# Addendum #3 Construction Manager as Constructer Services Hangar 2003 Renovations Fort Wayne International Airport

Issued: August 28, 2025

Hangar 2003 Renovation 4555 Altitude Dr Fort Wayne, IN 46819

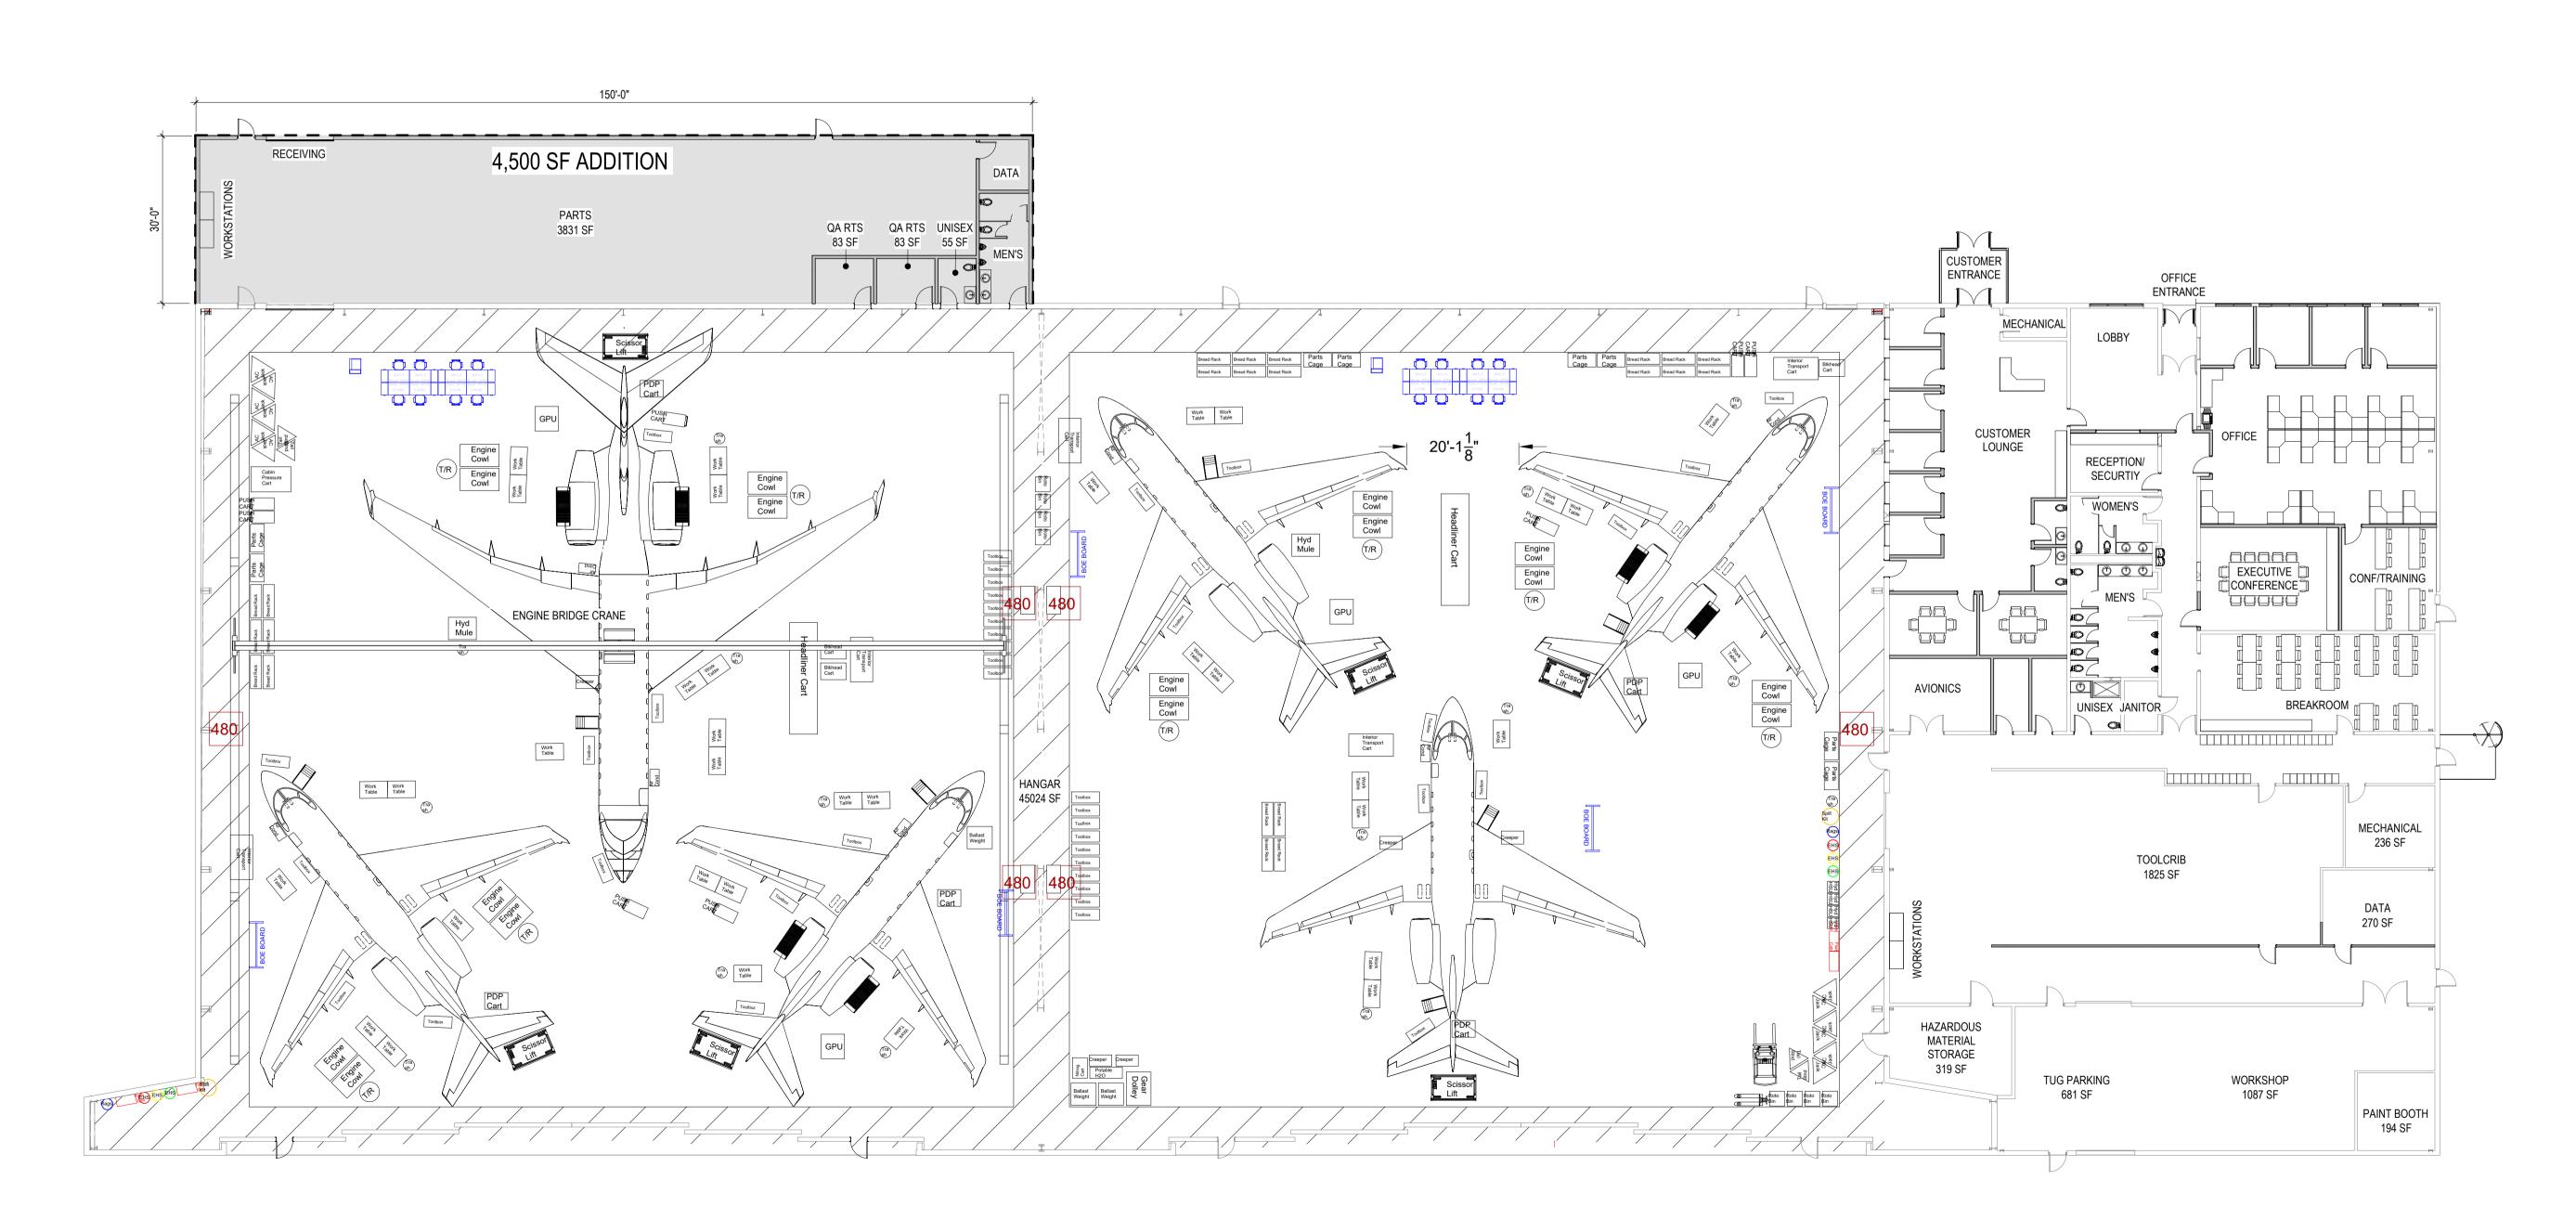
- The deadline for answering submitting questions is clarified as follows:
  - Section 13, Milestone schedule, Final Date for Submission of Questions is revised to September 3, 2025, to coincide with the date listed in Section 14. Responses to the questions will be issued via addendum as soon as possible thereafter.
- Attachment I-Architectural Design Narratives and Hangar Layout Schematic Plan are included with this addendum and added to the Scope of Work as follows:
